Docket Item # 4 & 5  
BAR CASE # 2016-0322 & 0323

BAR Meeting  
October 19, 2016

**ISSUE:** Partial Demolition, Addition/Alterations and Waiver of Rooftop HVAC Screening Requirement

**LOCATION:** 609 Cameron Street

1 Site Plan, 609 Cameron Street  
A-1 1" = 10.0'

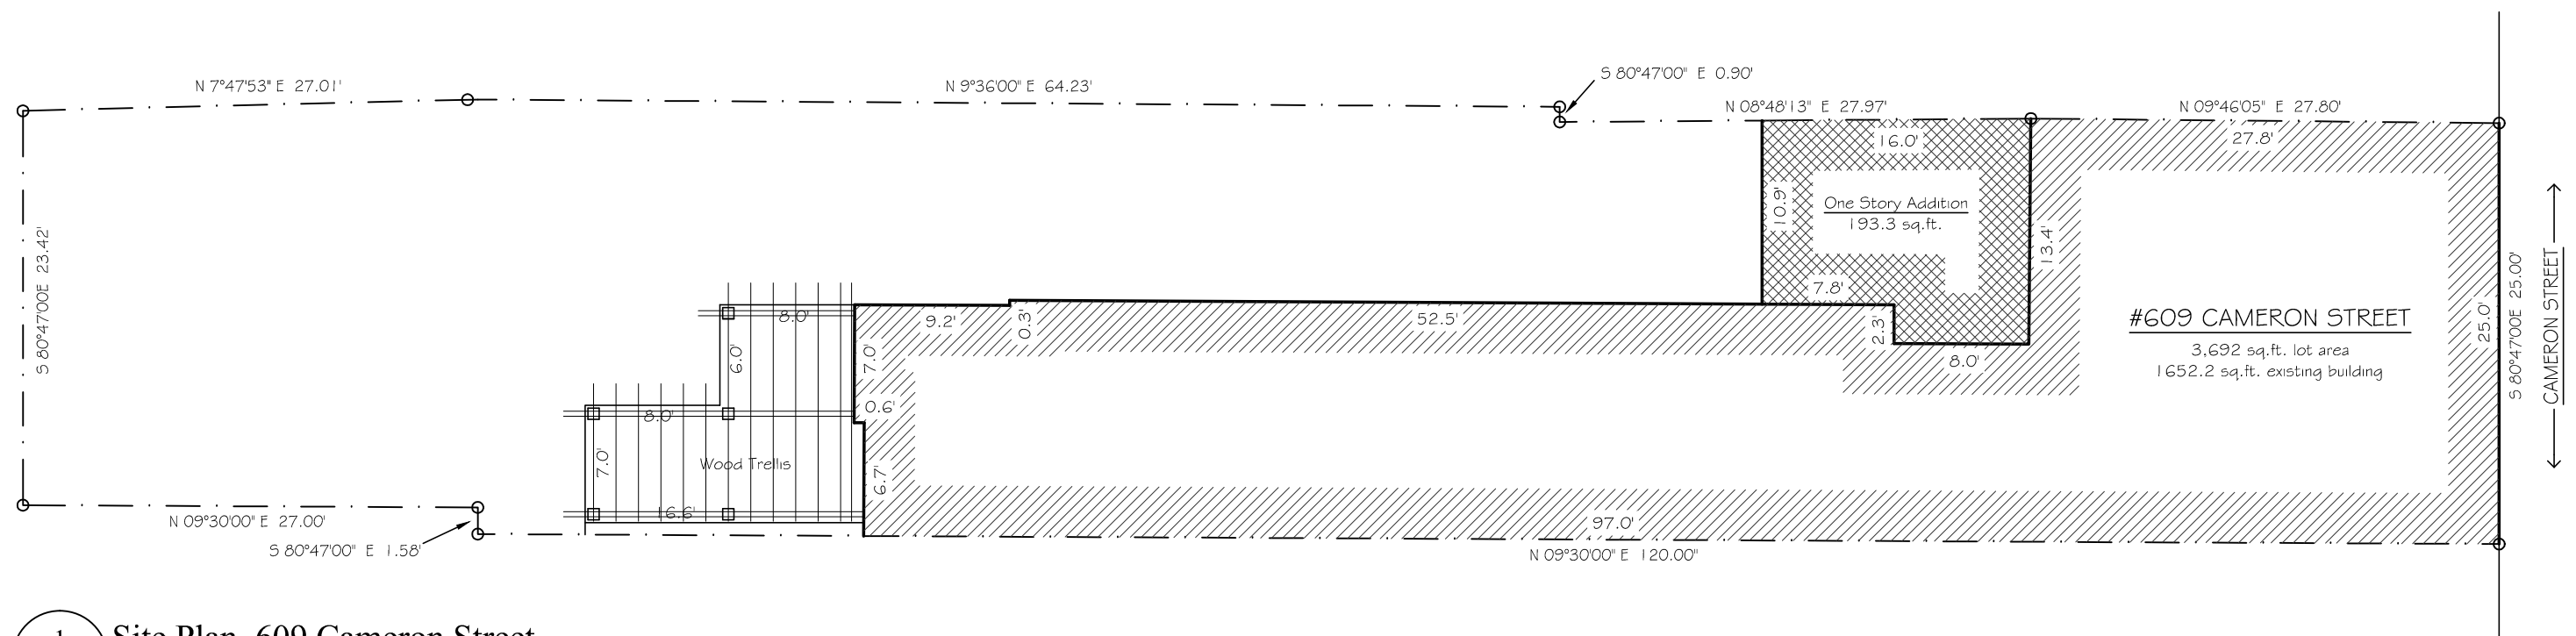
C-1 Based on the submitted site plan and plat, the proposed project will comply with zoning. The open space calculation appears to be incorrect. Staff calculates 1778.96 square feet of open space. Applicant should submit an open space plan to confirm.

C-2 Applicant must resolve the discrepancy between the lot area on the plat (3,692 square feet) and the square footage in real estate records (3,675 square feet) prior submitting for building permit.

Applicant should reconcile information with zoning staff prior to submitting for building permit.
